## **GENERAL APPLICATION**

November 16, 2017

#### Re: Cumberland Farms – SR 84 &

The following is a response to staff comments. Below are the comments along with our responses in bold:

**CFG05.0**

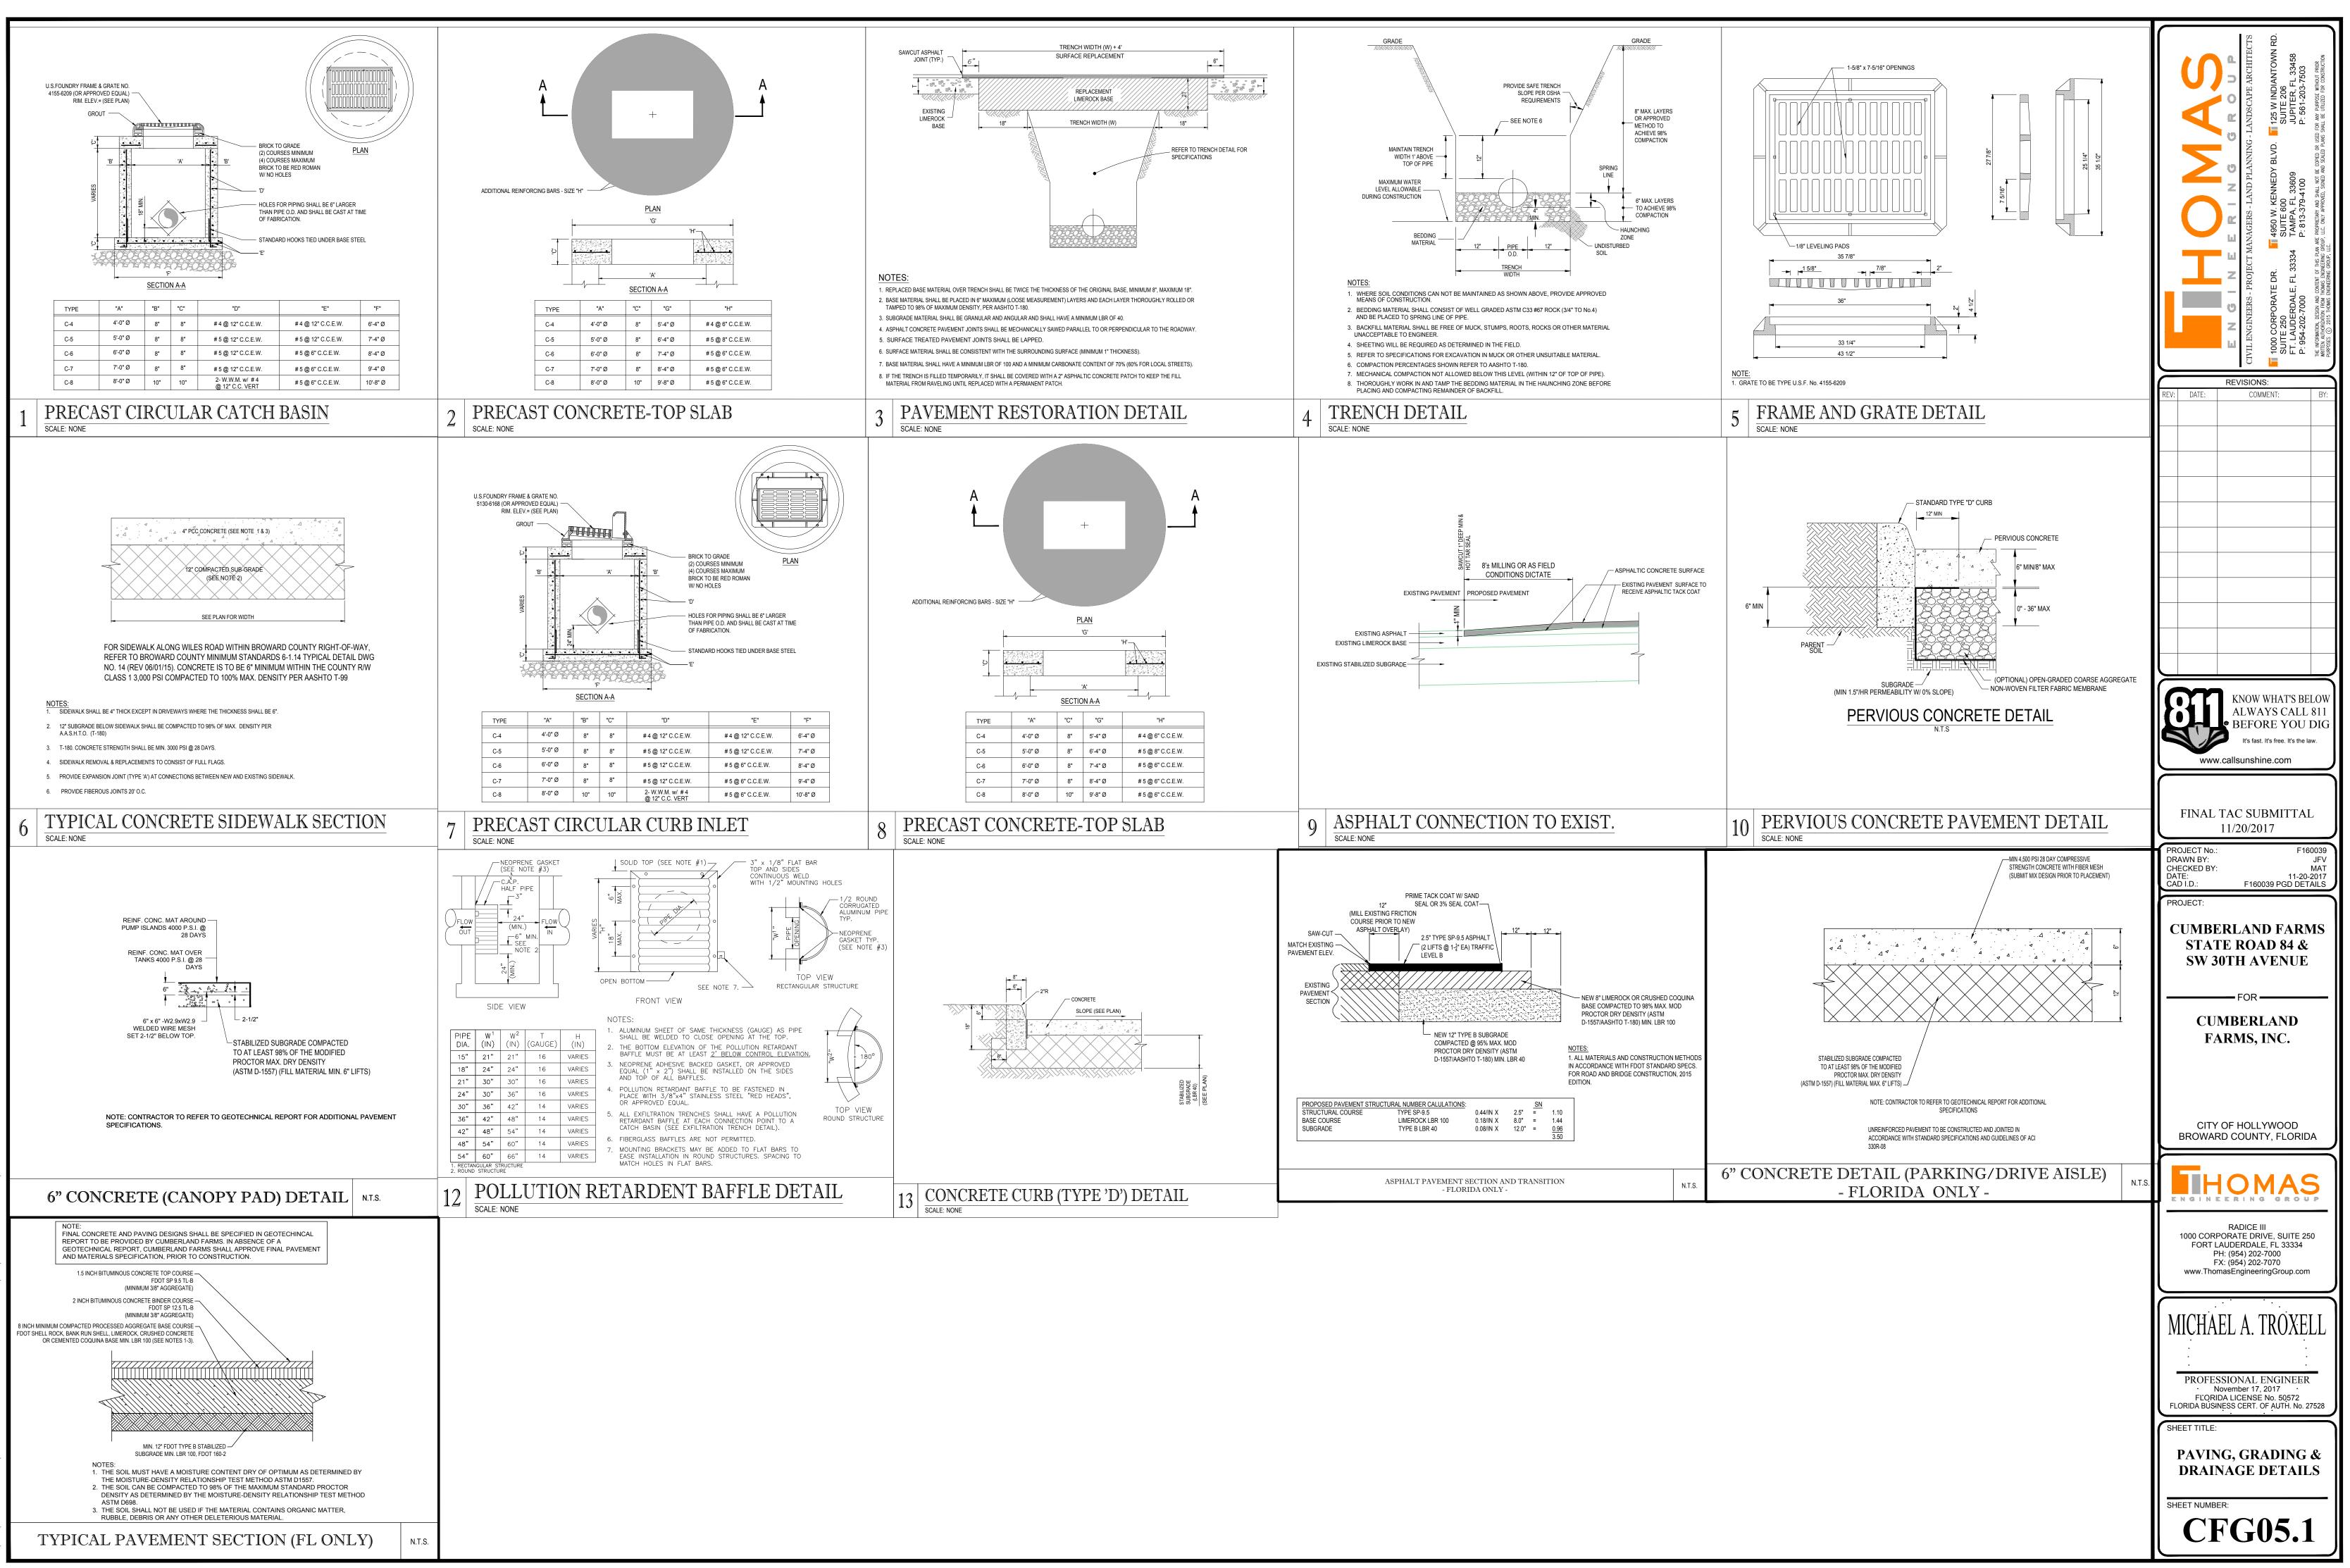
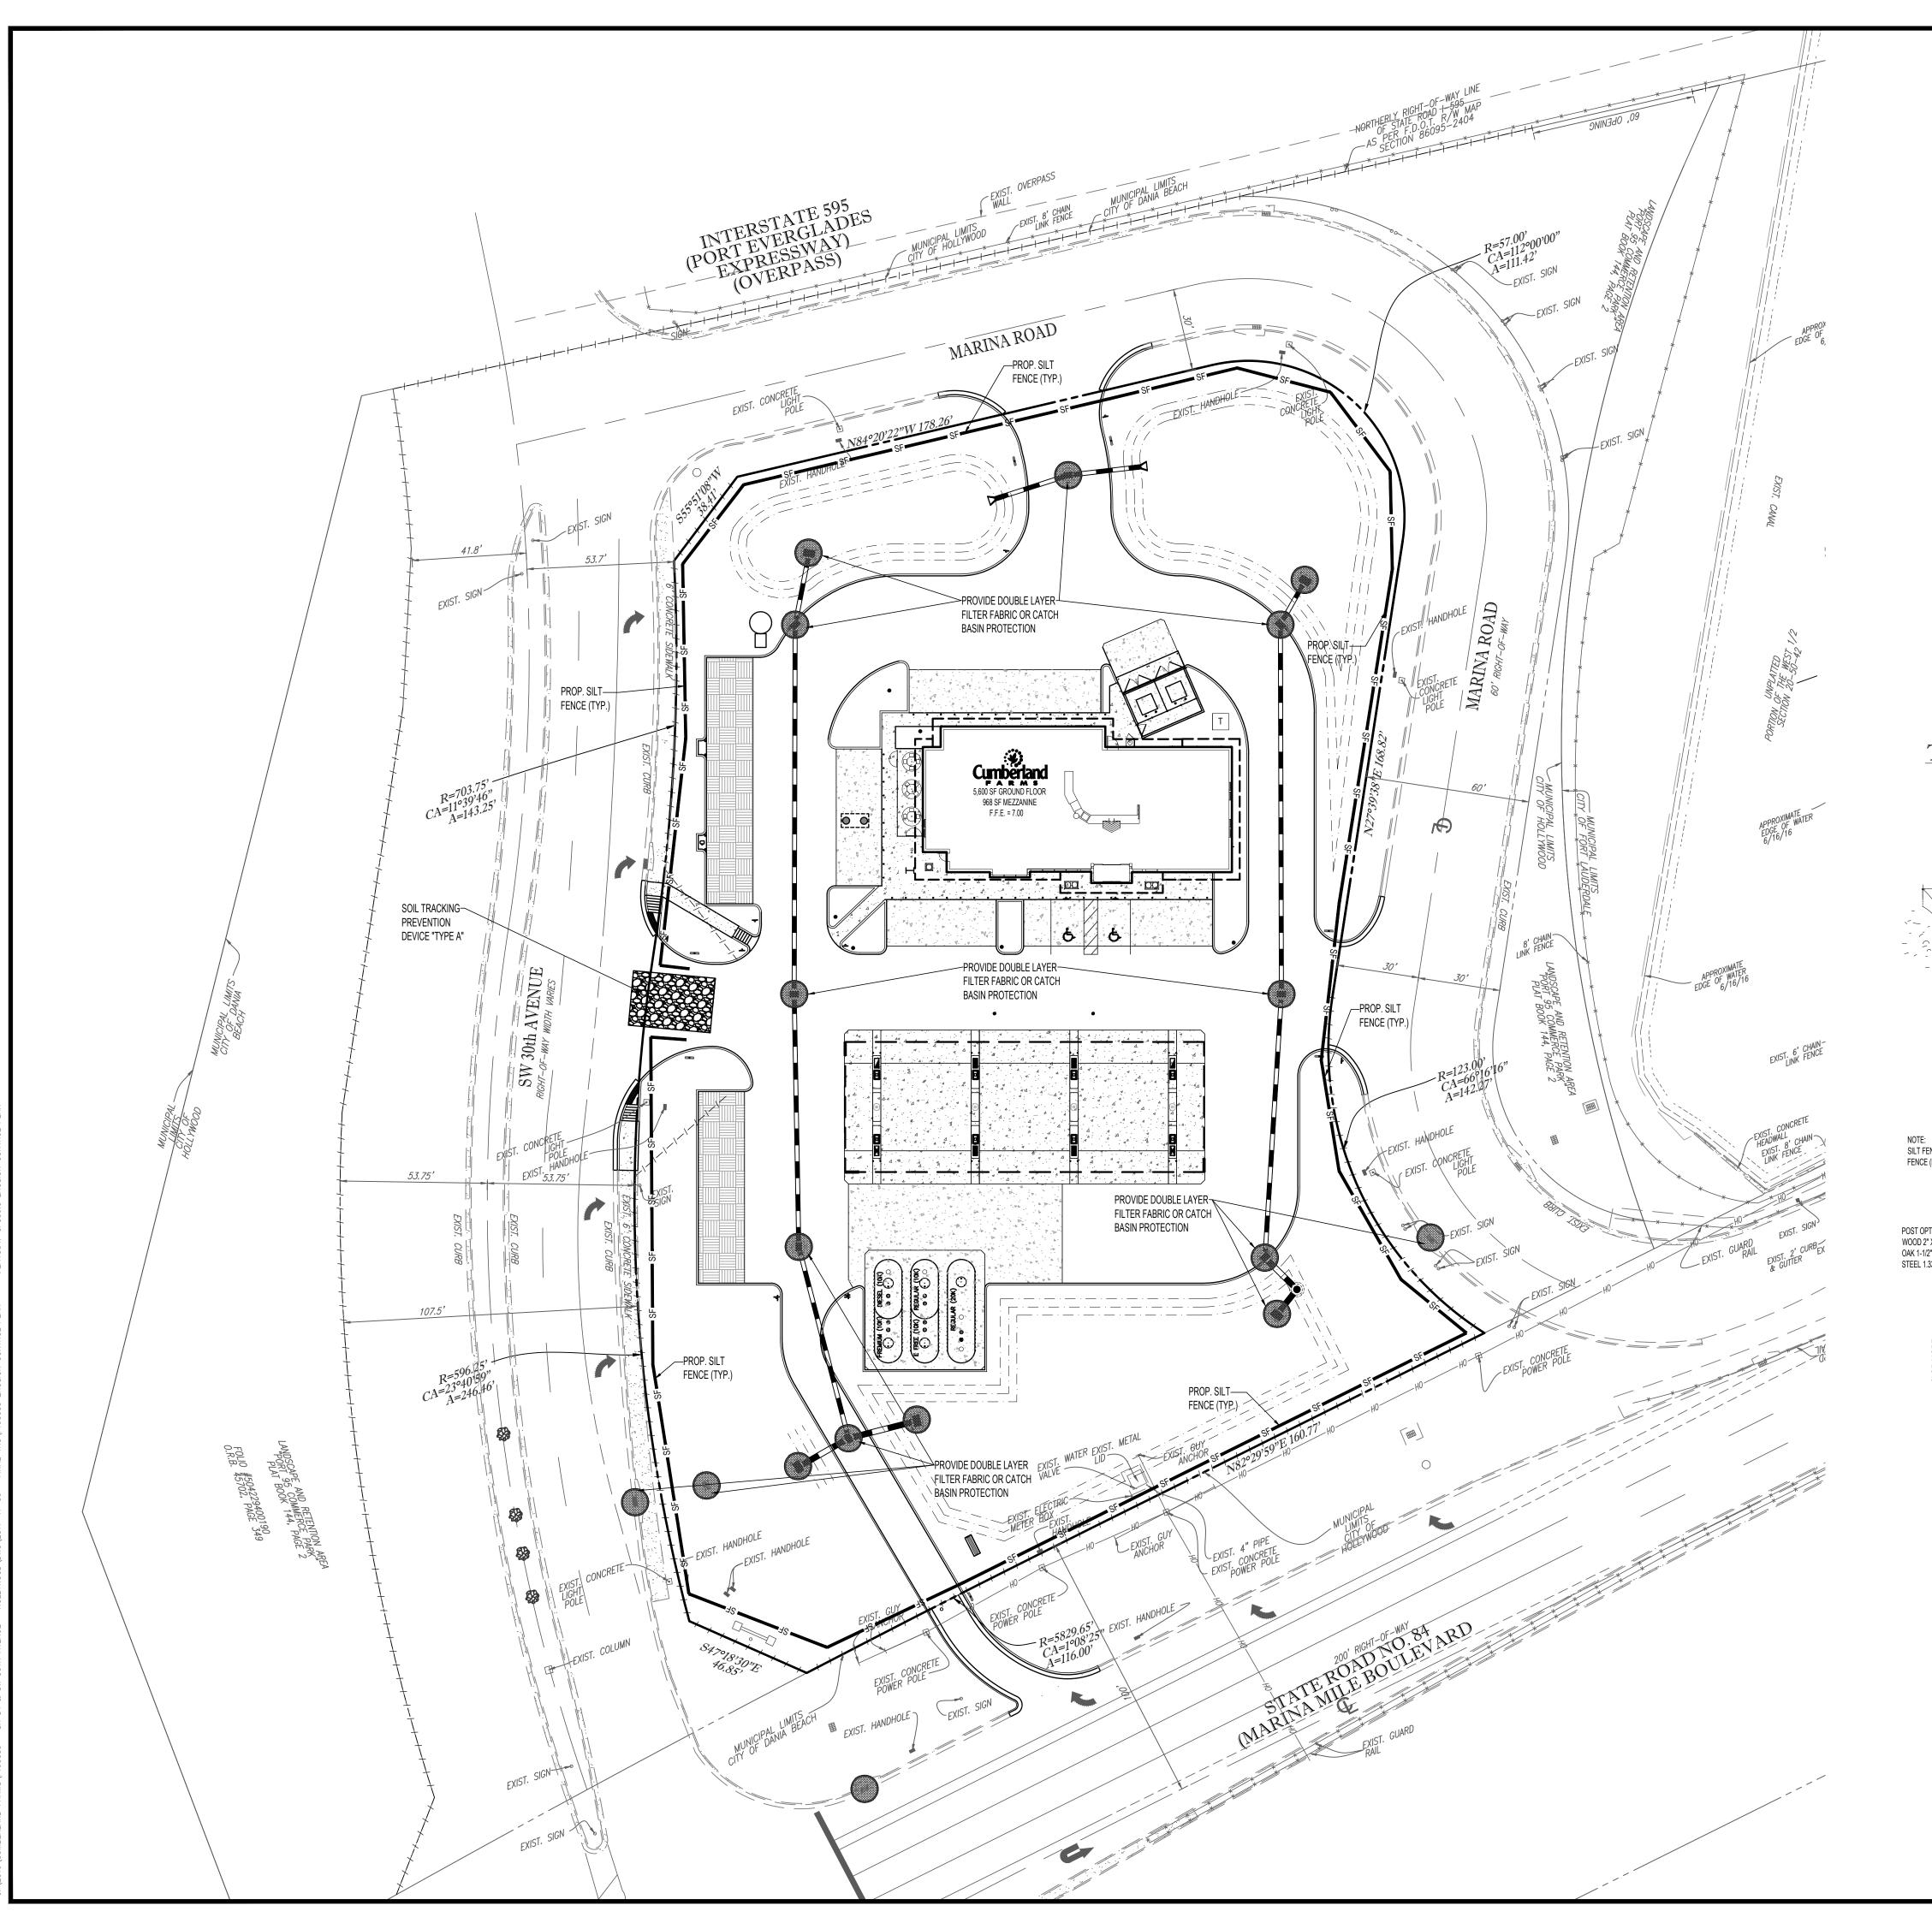
1. Provide Water, Sewer and Drainage plans for review.

**Response:** Water, sewer, and drainage plans have been provided. Refer to sheets CFG5.0 and CFG07.0. A water-sewer availability letter from Broward County Water Wastewater services has been provided.
